DART AEROSPACE LTD	Work Order: 77734
Description: Crosstube Assembly (205/212/412 High Fwd)	Part Number: D212-664-141
Inspection Dwg: D212-664-141 Rev: D	Page 1 of 1

DRAWING NO. D212-664-141	TITLE XTUBE ASSY (205/212/412 HI FWD)	REV. D	DART AEROSPACE LTD ENGINEERING ORDER		D.E.O. NO. D212-664-141-D-1	SHEET NO. SHEET 1 OF 2	SCALE NTS
DRAWN	CHECKED	MP	MFG. APPR.	ER	APPROVED	MP	DE APPR.
DATE 11.04.07	DATE 11.04.11		DATE 11.04.12		DATE 11/04/12		DATE 11.04.12

DRAWING NO. D212-664-141	TITLE XTUBE ASSY (205/212/412 HI FWD)	REV. D	DART AEROSPACE LTD ENGINEERING ORDER	D.E.O. NO. D212-664-141-D-1	SHEET NO. SHEET 2 OF 2	SCALE NTS
DRAWN	CHECKED <i>CP</i>	MFG. APPR. <i>E</i>	APPROVED <i>WD</i>	DE APPR. <i>WD</i>		
DATE 11.04.07	DATE 11.04.11	DATE 11.04.12	DATE 11/04/12	DATE 11.04.12

DRAWING NO. D212-664-141	TITLE CROSSTUBE ASS'Y (205 HI FWD)	REV. D	DART AEROSPACE LTD ENGINEERING ORDER		D.E.O. NO. D212-664-141-D-2	SHEET NO. SHEET 1 OF 1	SCALE NTS
DRAWN <i>IP</i>	CHECKED <i>ASS</i>	MFG. APPR. <i>AS</i>	APPROVED <i>MD</i>		DE APPR. <i>HT</i>		
DATE 11.07.15	DATE 11.07.20	DATE 11.07.21	DATE 11/07/21		DATE 11.07.21

**D212-664-141/-141B
ASSEMBLY DETAIL**

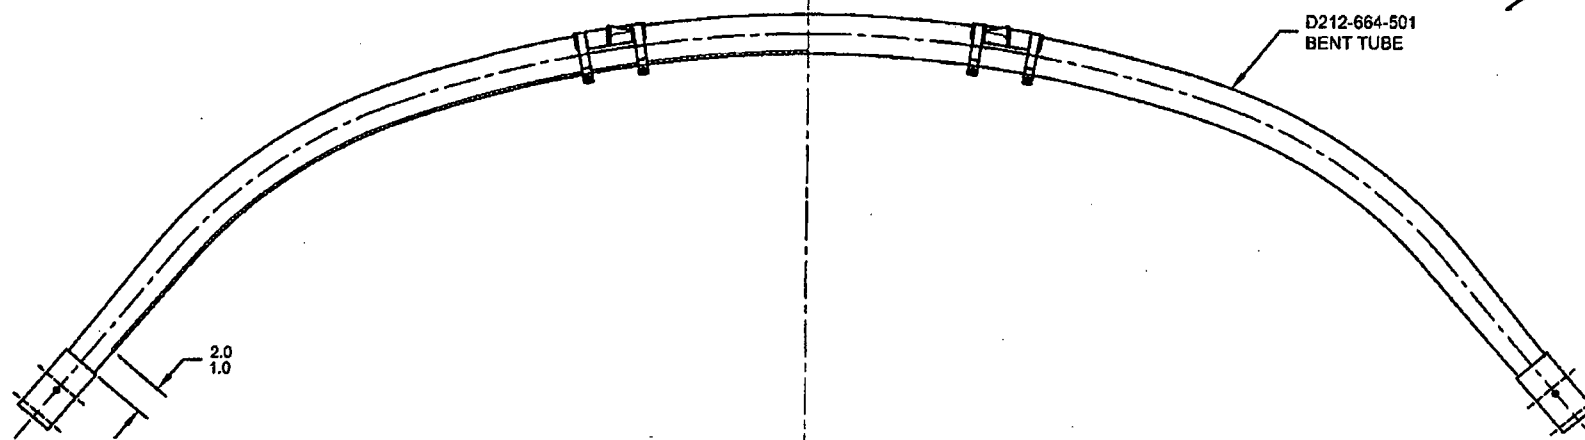
PURPOSE:

ADD AN INSPECTION WINDOW TO UNDERSIDE OF CROSSTUBE.

NOTES 2 OF SHEET 1 IS AMENDED AS FOLLOWS:

- 2) FINISH: CHEMICAL CONVERSION COAT PER DART QSI 005 4.1
PRIME INSIDE AND OUTSIDE PER DART QSI 005 4.2
MASK UNDERSIDE OF CROSSTUBE AS SHOWN (HATCHED AREA) AND
PAINT OUTSIDE PER DART QSI 005 4.2
REMOVE MASKING AND APPLY CLEAR COAT

MASK AREA PRIOR TO PAINTING.
REMOVE MASKING AFTER PAINT
AND APPLY CLEAR COAT
